STATE OF MAINE
DEPARTMENT OF TRANSPORTATION
16 STATE HOUSE STATION
AUGUSTA, MAINE
04333-0016

May 11, 2009
Subject: **Auburn**
Federal Project No's. STP-1273(700)S &
STP-1305(900)S
State Pin No's. 012737.00 & 013059.00
Amendment No. 2

SPECIAL PROVISION
SECTION 607
FENCE
(CEDAR RAIL FENCE)

Three Rail Split Rail Fence

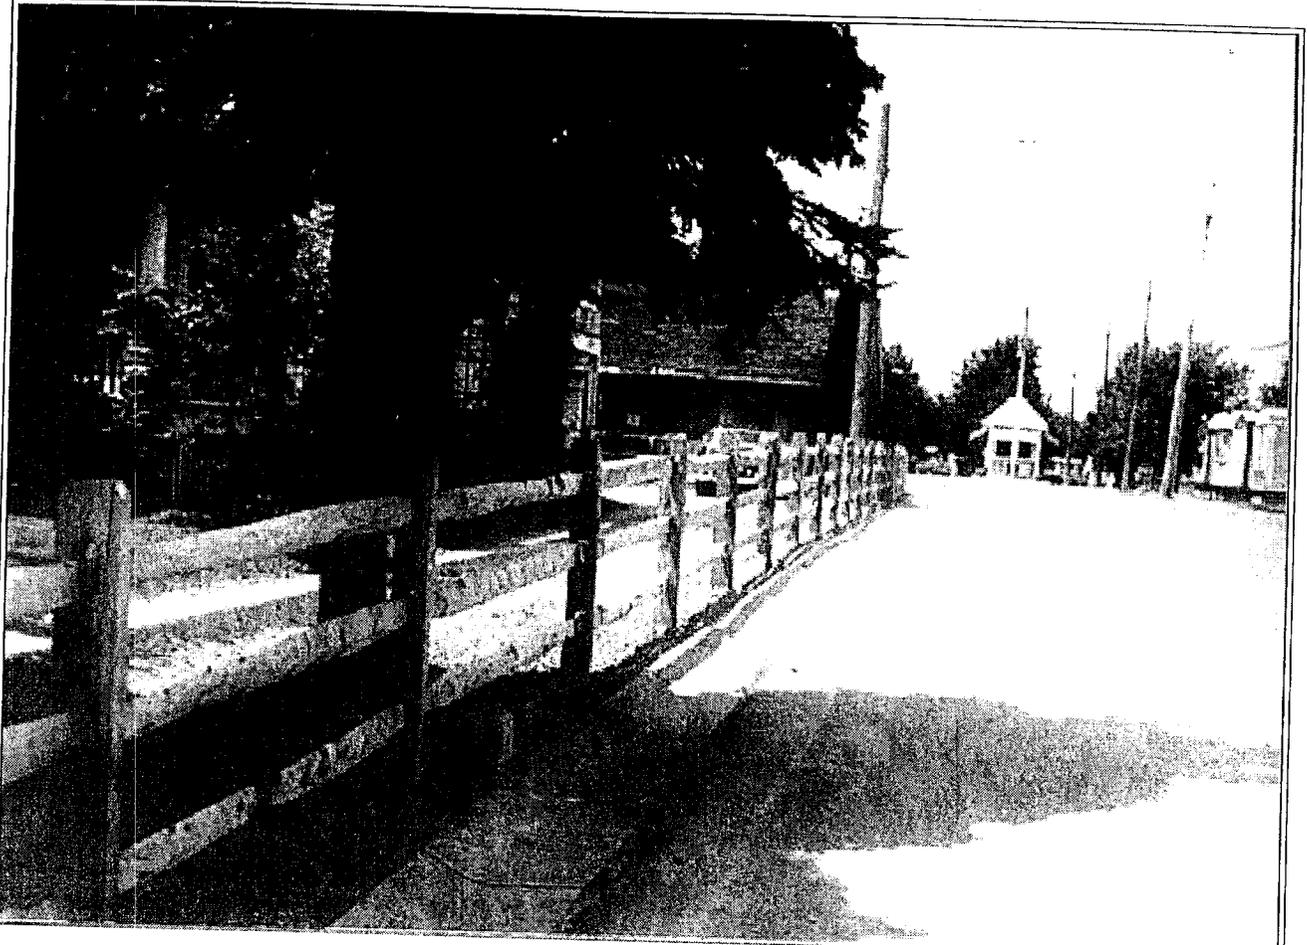
In the Bid Book, after page 79, **INSERT** the attached "SPECIAL PROVISION, SECTION 607, FENCE, (CEDAR RAIL FENCE), 2 pages dated May 7, 2009.

Question: Would you supply a detail for Item 607.22, Cedar Rail Fence?

Response: Please see the above change.

Materials Posts and rails shall be fabricated with northern white cedar. Posts shall be nominal 6" x 6" x 7-foot length; Rails shall nominal 4" x 6" x 11 foot length.

Posts shall be set as shown on the plans in augured or hand dug holes approx 3' in depth such tat the tops are 48" above finish grade. The fence shall be placed as shown on the plans or as directed by the Engineer. There shall be 3 rails for each section of fence.

After the posts are placed, and the rails are installed and the posts aligned, the holes shall be backfilled with earth placed in 12" layers and compacted. The completed fence shall have the tops of the posts at a uniform height above ground following the gradient of the ground.
